ORIGINATION FORM

Proposed Revisions to a Standard Plans Index (Please provide all information — Incomplete forms will be returned)

Index Number: 641-020

Index Title: Concrete CCTV Pole

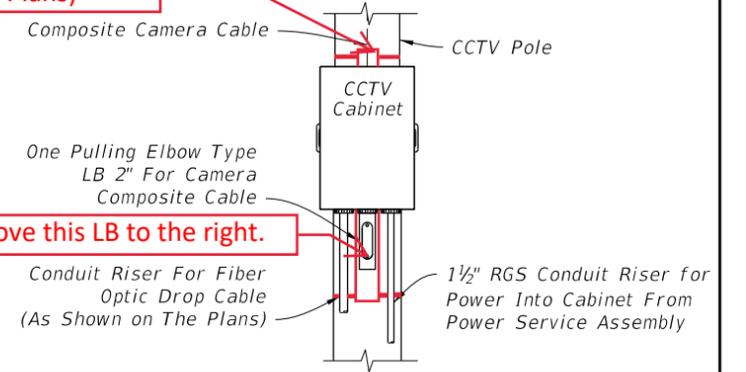
Add note: "Cabinet Adapter Bracket (As Shown on Plans)"

Move this LB to the right.

DETAIL "D"

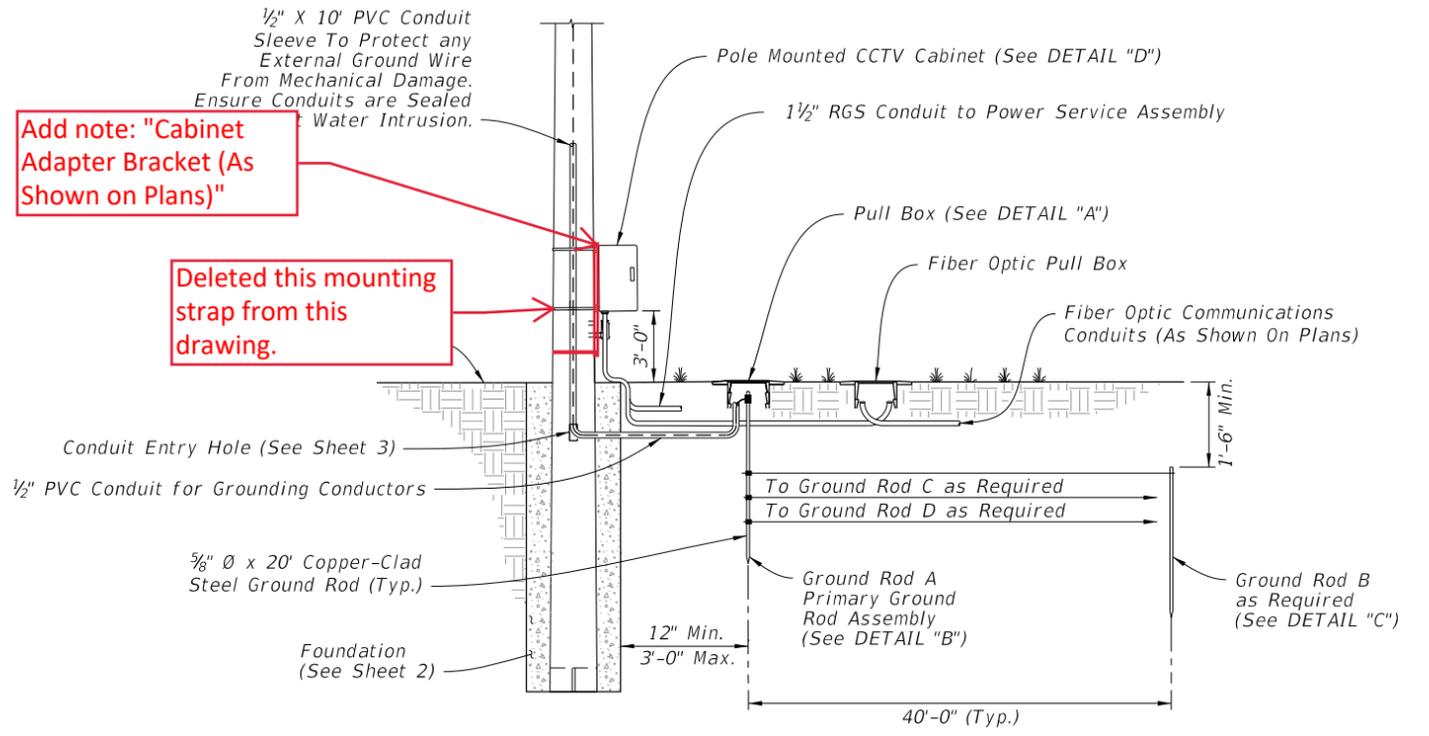
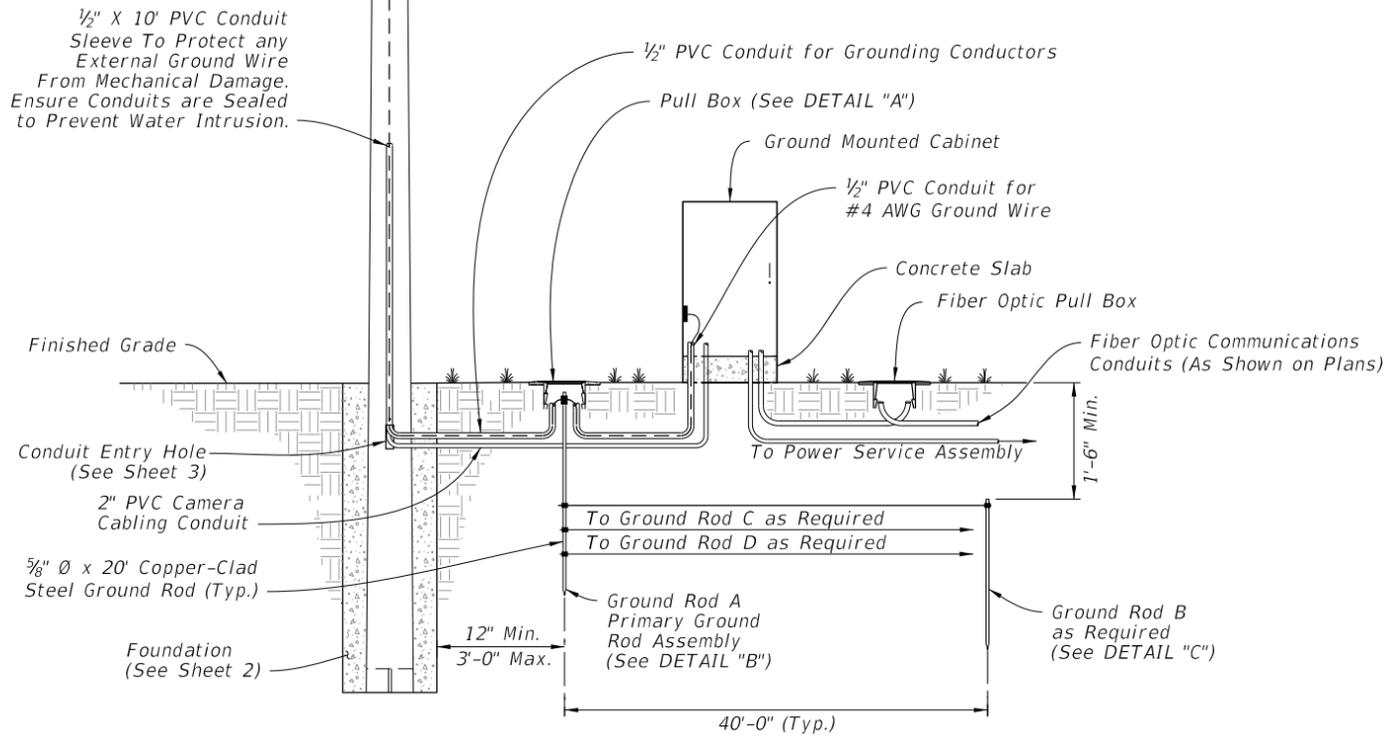
Sheet 5: Deleted the "Pole Plate With Stainless Steel Band" and Added new "Cabinet Adapter Bracket" shown in DETAIL "D" and the POLE MOUNTED CABINET detail.

Add note: "Cabinet Adapter Bracket (As Shown on Plans)"

Deleted this mounting strap from this drawing.

"676-2.5.9 Adapter Bracket: If shown in the plans, provide an adapter bracket for pole mounted cabinets that is slotted or otherwise designed to allow banding straps to be installed to avoid pole handholes."
